## SP AUSNET REVENUE RESET

### Advice on revised revenue proposal

*Document Reference:* \2159297A\SPA2008Reset\_Response to DD\_v5\_0.doc

08 January 2008

Figure 2-2 – Economical analysis for pin and cap insulators

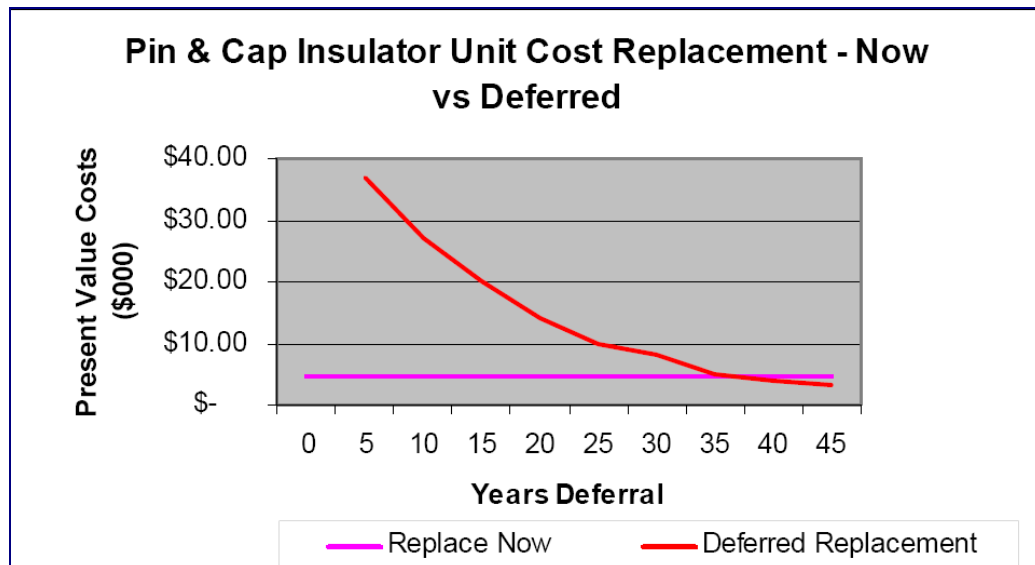
PB considers that there are a number of subjective assumptions included in SPA's economic assessment that overstate the break-even period<sup>4</sup>. Nevertheless, accounting for some sensitivity analysis concerning the replacement costs and possibilities of capturing economies of scale, PB is satisfied that the break-even period will be greater than 10 years and therefore that the inclusion of all assets for replacement as part of the wider project is an efficient and prudent outcome. Notably, PB accepts that the costs to replace the individual assets as described by SPA in Table 2-8 appear on the high side of the expected range, but reasonable for the defined scope if adopted as piecemeal projects.

**Figure 2-3 – Economic analysis for overall CT replacements proposals**

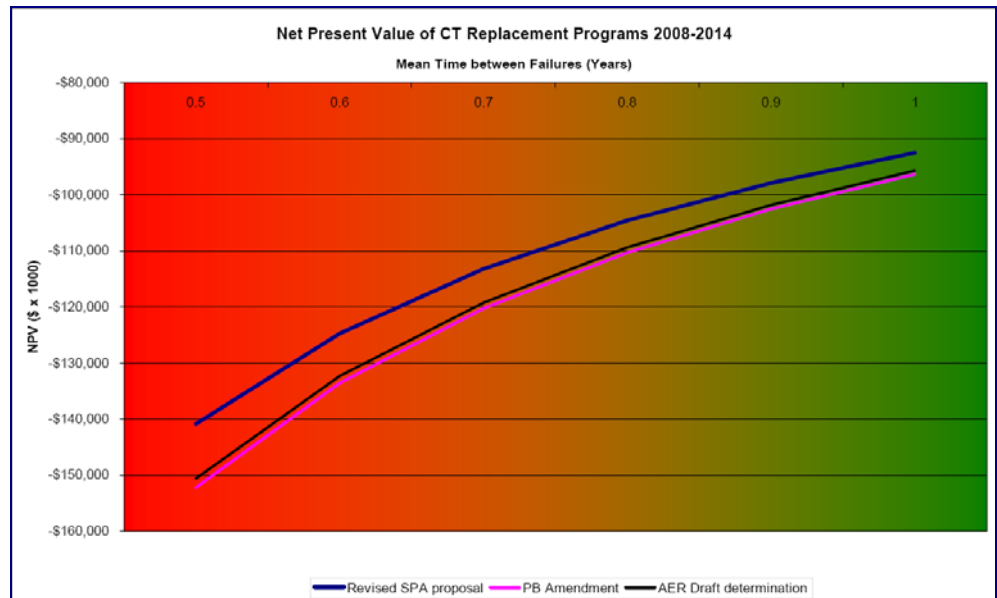
- the Net Present Value of the program of works recommended by PB is consistently lower than that of the SPA proposal across the relevant range of CT failure frequencies, as shown in Figure 2-3

- With respect to the net present value assessment of the overall CT replacement program (Figure 2-3), where the SPA proposal is shown to have a least cost NPV of \$92.4k compared with the AER's draft determination of \$95.7k (for a mean time between failures of 1 year), PB notes that the results are predicated based on the following key assumptions:

**Figure 2-4 – Economic analysis for optimised timing of CT replacements**

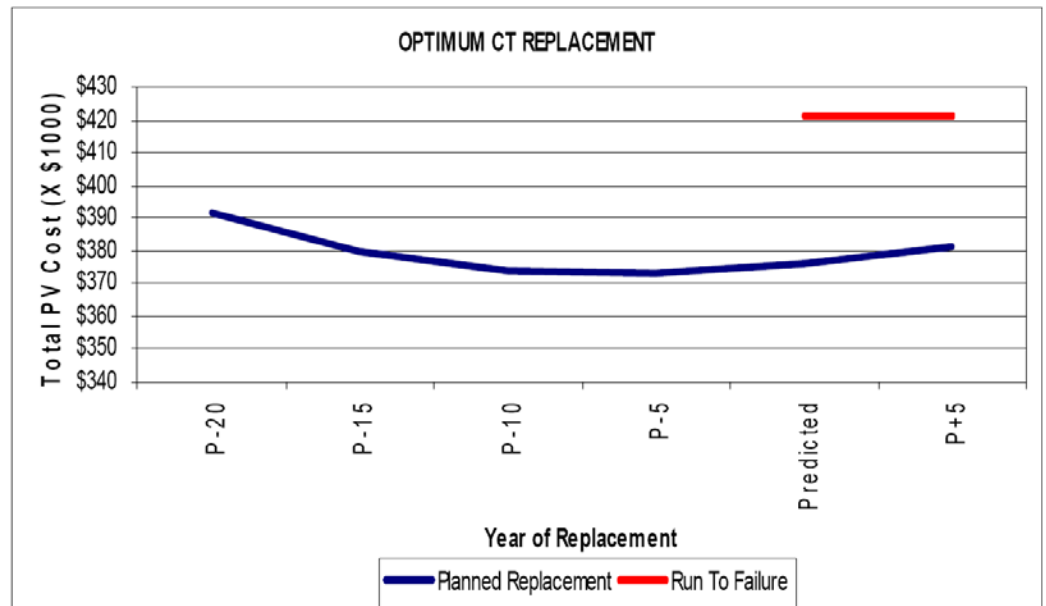
- Notwithstanding any discretionary safety margins implicit in SPA's life expectancy model<sup>18</sup>, PB concurs that a pre-emptive replacement approach presents a far more economical and prudent outcome than an explosive run-to-failure scenario (as supported in the comparison of the Total Present Value Cost of \$373k compared with \$421k in Figure 2-4).

- PB also acknowledges that as informed purely from the economical basis of Figure 2-4, replacement of generic CT's based on the modelled parameters appears optimal five years prior to predicted failure (\$373.3k). However, it is also noted that the variation in the Total PV Cost varies by only \$3k (<0.9%) between the investment at the time of the predicted life and replacement 10 years earlier, however, the economical outcome is highly sensitive to input assumptions, particular the capital cost and the consequential costs as described in Figure 2-5 where it is seen that capital costs reduce at investment closer to the predicted life occurs but where consequential costs reduce.

**Figure 2-5 – Breakdown of economic analysis for optimised timing of CT replacements**

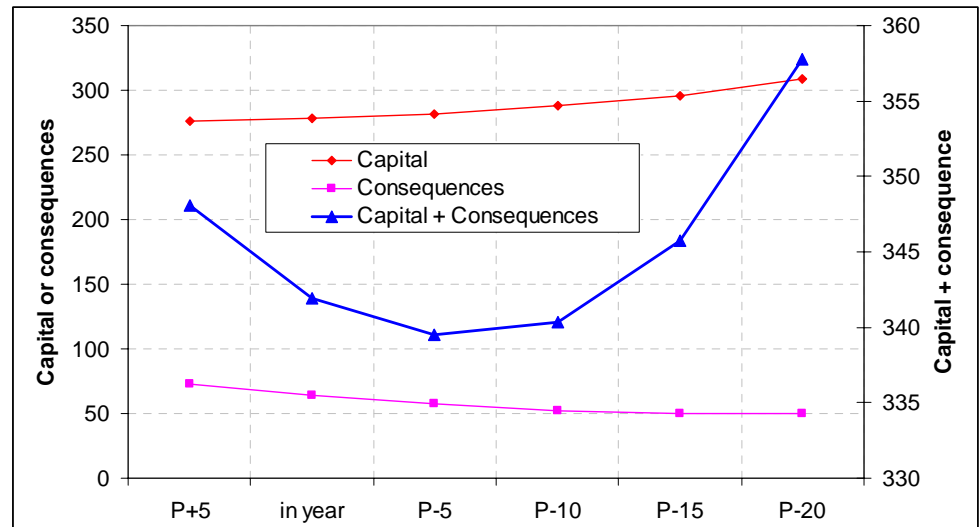
- The reactive opex and capex costs associated with a plant failure have been informed from five historic events across a range of voltages – as there is considerable variation in these costs (i.e. for 500 kV plant vs. 66 kV plant), PB considers a more appropriate model would be based on specific voltage levels and targeted more appropriately to the CT's excluded by the AER's draft decision.

**Figure 2-6 – Economic analysis for optimised timing of CT replacements with reduced community costs**

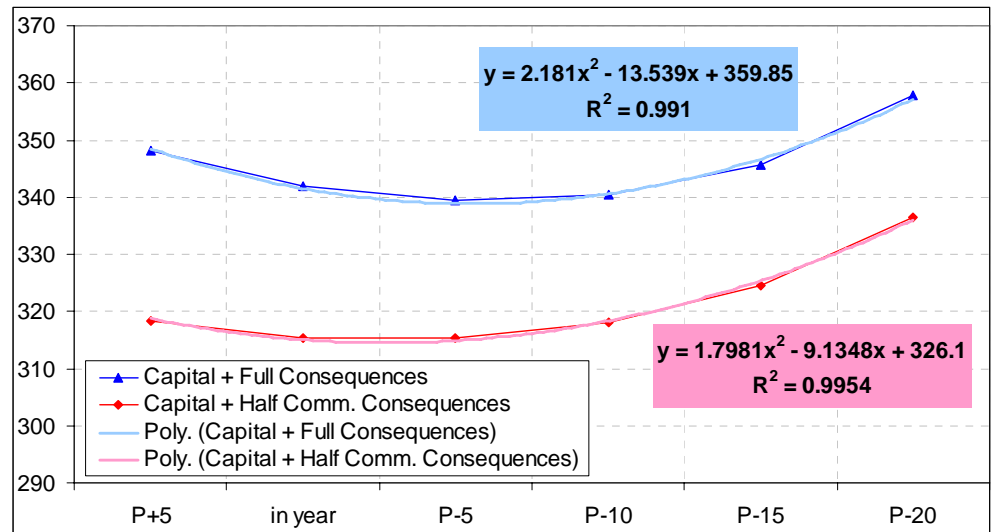
- With the exception of Springvale (SVTS) and Tyabb (TBTS), an explosive CT failure at most stations with targeted CT replacements excluded by the AER is not likely to lead to loss of supply. Rather the event is more likely to lead to network constraints, which based on historical evidence will result in a community cost of only 5% of that involving loss of supply. As the consequential costs reduce, the benefit of deferred replacement becomes more apparent to the point where it could be reasonably argued that the optimum economic timing can reduce to 0 - 5 years. Figure 2-6 shows the reduction in optimal timing when the community costs implicit in the consequential costs assumed by SPA to occur for all CT failures is halved.

**Figure 2-7 – Economic analysis for optimised timing of 500 kV CT replacements**

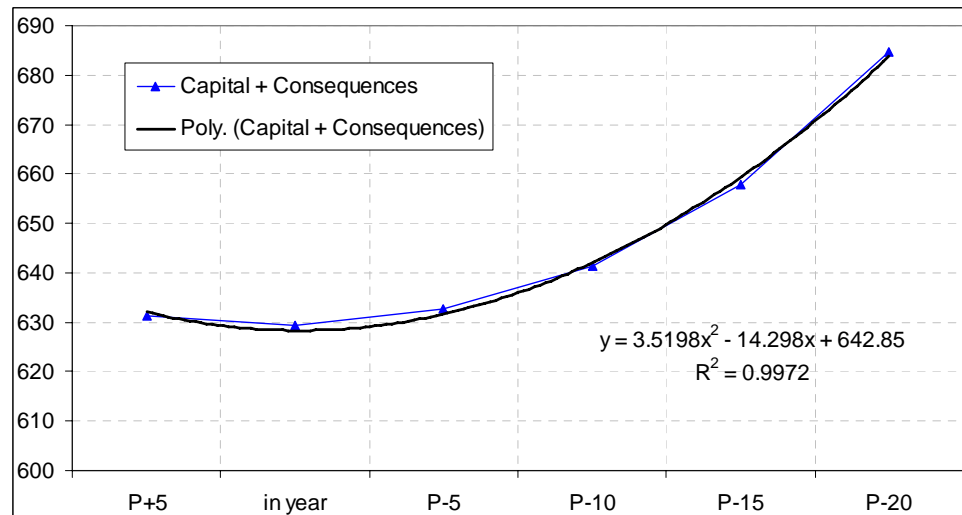
- In undertaking sensitivity analysis, PB has concluded that for a 500 kV CT replacement which has a capital cost of \$565k (compared with a 220 kV CT of \$275k as used in the generalised model) the optimum timing for pre-emptive replacements is at the predicted life expiry given the increased benefits of deferring larger investments. This is seen in Figure 2-7, and is applicable in the case of seven of the twenty-four CT's deferred as part of the AER's draft determination and supports the decision to defer these into the next regulatory period.

**Figure 2-8 – Economic analysis for optimised timing of 500 kV CT replacements**

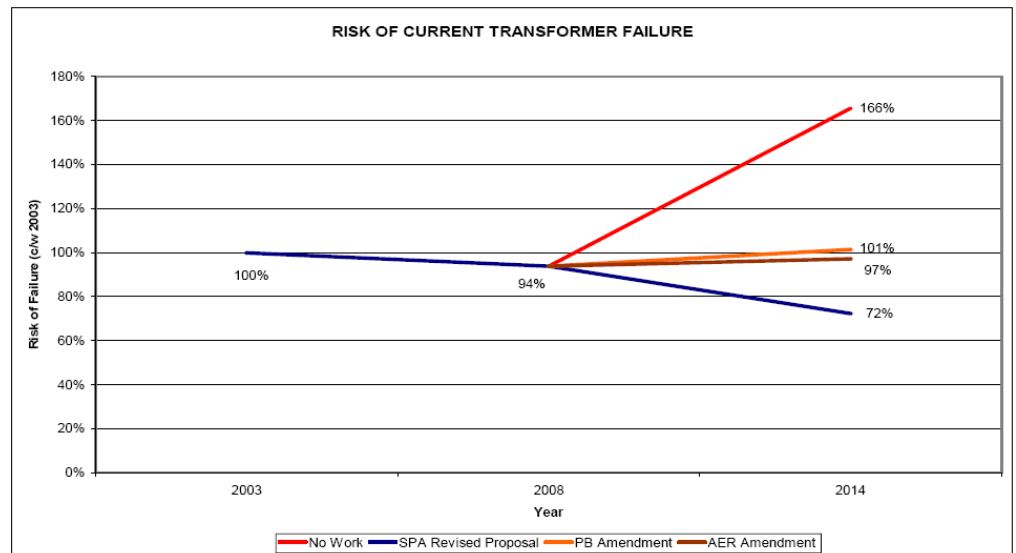
- the use of a Mean Time Between Failure (MTBF) rate of 1 (or less than 1)
- the relative and cumulative risk of CT failures which is used as a direct proxy for the likelihood a failure in any given year, as described in Figure 2-8

With respect to this last point regarding the CT asset failure risk and forecast MTBF, PB notes that the failures predicted by SPA's quantitative model are normalised around the 2003 levels (refer to Figure 2-8) based on a theoretical and absolute failure rate of 3.3 units per annum (or a MTBF of approximately one every 114 days), given the model's population of around 1280 units in 2007. The model appears to be overstating the actual level of risk experienced by SPA, which has only experienced 5 explosive failures since December 2002 over a total population of 1852 units<sup>23</sup> - or about 1 per year. While PB concurs with SPA that the MTBF has reduced significantly given the spate of recent failures<sup>24</sup> over a short period of time, PB considers the absolute model outputs are not directly applicable to describe SPA's CT failure risk or the MTBF of its fleet. Accordingly and appropriately, SPA's application and presentation of the risk model information has been focussed on the models relative rather than absolute failure risks as time progresses. Specifically, in its economic analysis for overall CT replacements (refer to Figure 2-3) SPA has quantified its CT replacement benefits using a relative change in risk for a given MTBF based on 1 failure in 2003. It has also stated that the reduced CT replacement program proposed by the AER will expose field workers to the hazards of at least one CT failure per annum through the period 2008-2014<sup>25</sup>. Given that SPA has targeted its replacement of 203 single phase CT's in the years 2006 and 2007 (including all of the high risk 500kV CT's at Moorabool which attributed two of the explosive failures in 2002 and 2005) and combining this with the balance of the forecast allowance under this program – PB is of the view that the MTBF will be increasing from the existing level around 1 per annum. This is somewhat supported by the observation that there have been no explosive CT failures since October 2006.
